TN263

Updating Your Application from the RCM3200/RCM3220 to the RCM3209/RCM3229

Figure 1. RCM3200/RCM3220 and RCM3209/RCM3229 LED Layouts

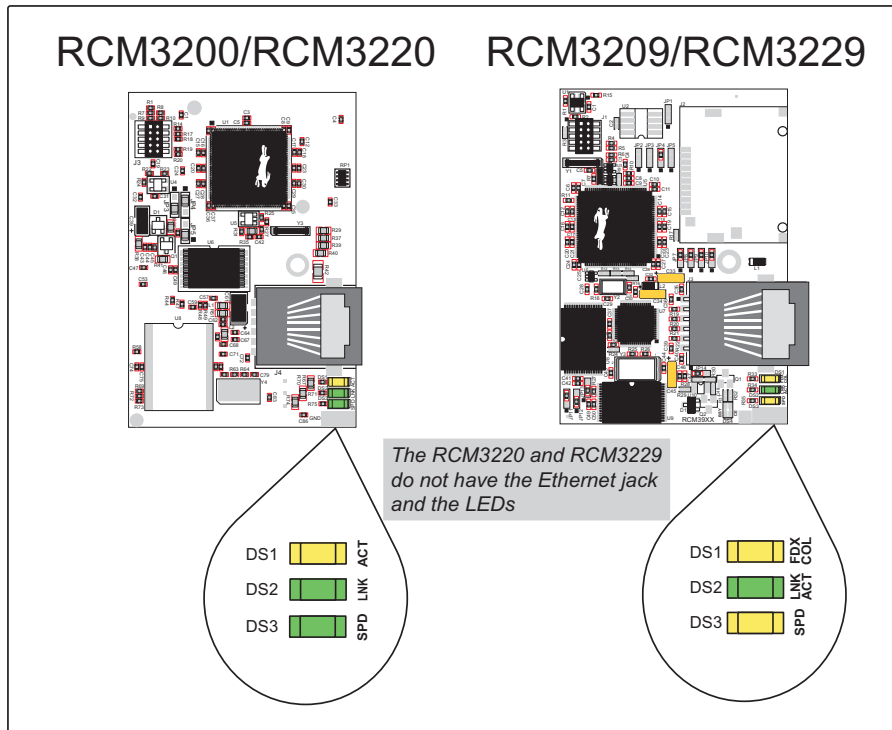
The **LNK/ACT** LEDs have been combined to one LED on the RCM3209, and the RCM3209 has an **FDX/COL** LED where the **ACT** LED was on the RCM3200. The RCM3229, like the RCM3220, has no LEDs and no Ethernet.

Figure 1 compares the RCM3200/RCM3220 and the RCM3209/RCM3229 component layouts. The LED placements on the boards remain unchanged.
